**SAN FRANCISCO UNIFIED SCHOOL DISTRICT
FACILITIES DESIGN AND CONSTRUCTION**

ADDENDUM NO. 1

PROJECT: ADA Improvements at Leola Havard Early Edu. School **DATE:** April 17, 2015
1520 Oakdale Avenue, San Francisco, CA
SFUSD Project Number: 11700

REF : A9.1

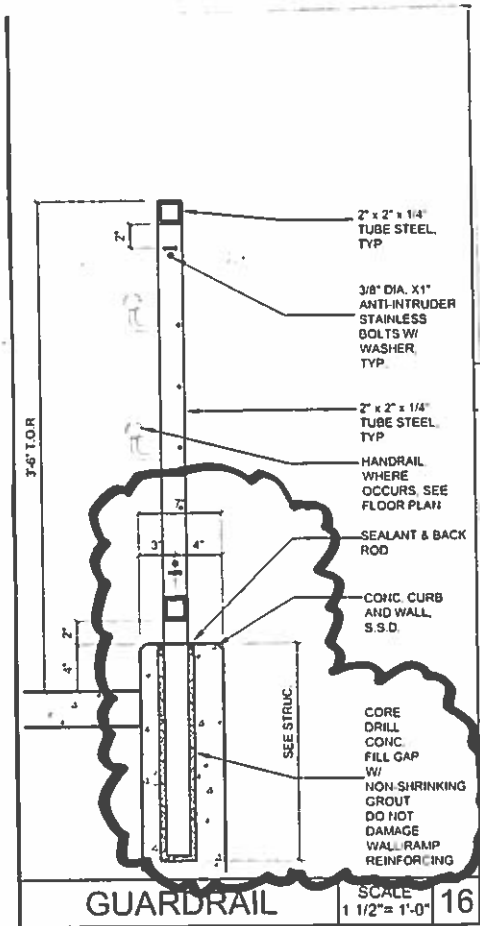
Description: Revised curb at typical railing section detail 3 and add a guardrail detail 16, instead of a HSS provides a concrete curb, part of the wall construction with core drills for the posts. Refer to SK-1 and SK-2

SHEET NUMBER
9K-3

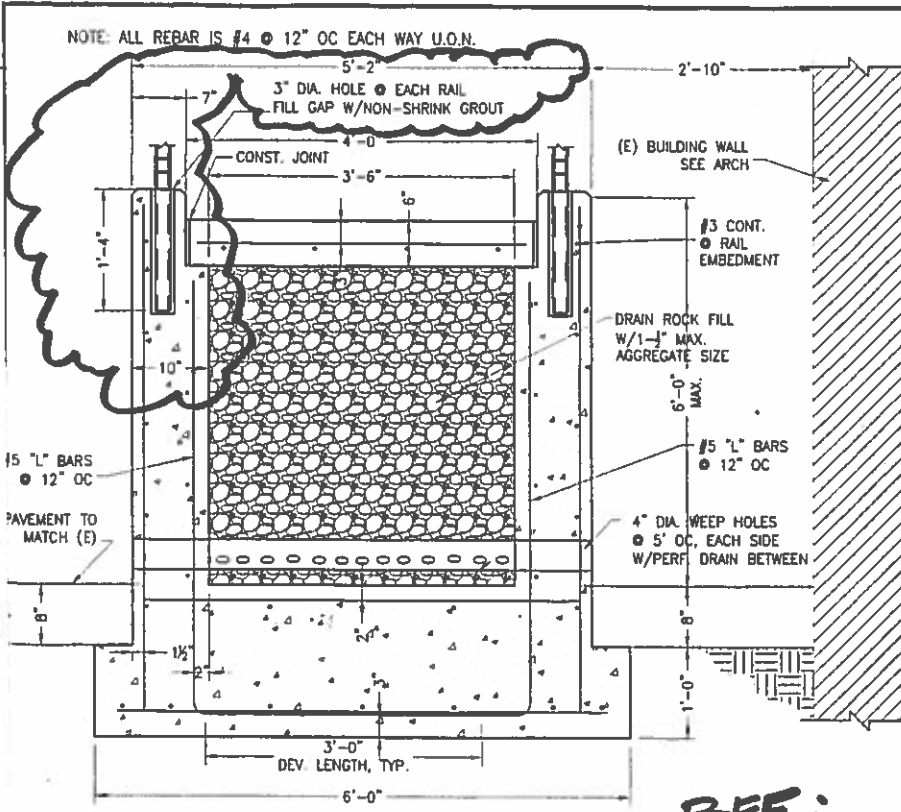
Description: Revised dimensions – coordination with the revised 7 inches wide curb design. Refer to SK-3

SHEET NUMBER
 SK-4

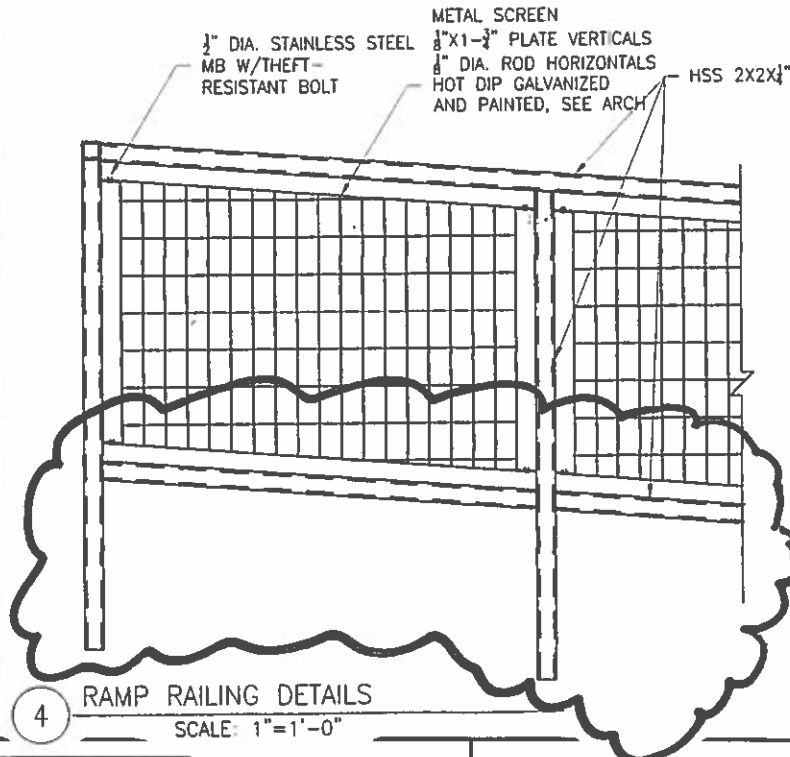
Description: Revised curb at typical ramp section detail 1 detail and 4, instead of a HSS provides a concrete curb, part of the wall construction with core drills for the posts. Refer to SK-4
